Product / Process Change Notification (PCN)

PCN #: PCN_ConFPC_20220221
Affected Series: WE-FPC;
 68612814122; 68612814422;
 68613014122; 68613014422

PCN Date: January 21, 2022

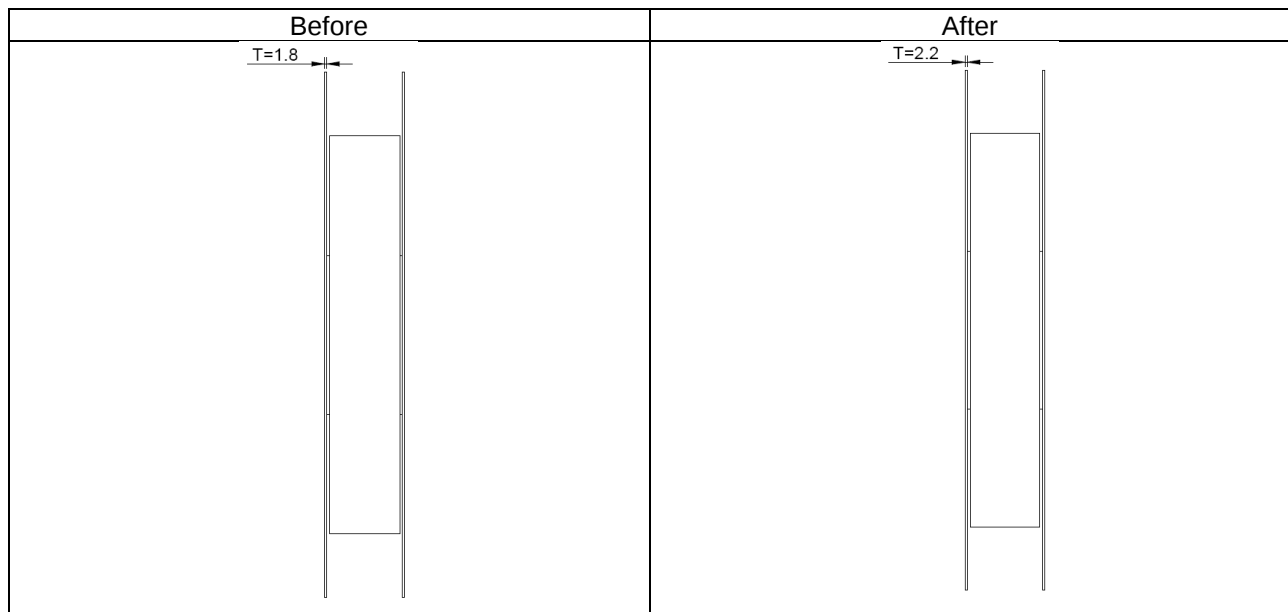
DETAIL OF CHANGE:

- The reel plastic thickness will be changed from 1.8mm to 2.2mm, it will help the reel plastic material more rigid.

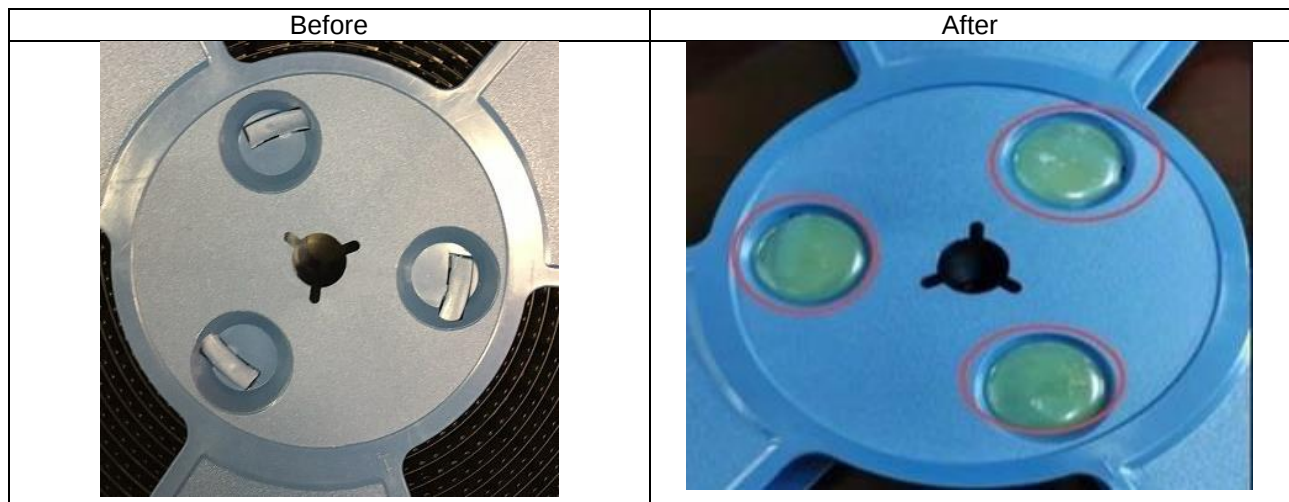
2. The glue on the top of plastic reel will be added to enhance the reel strength.
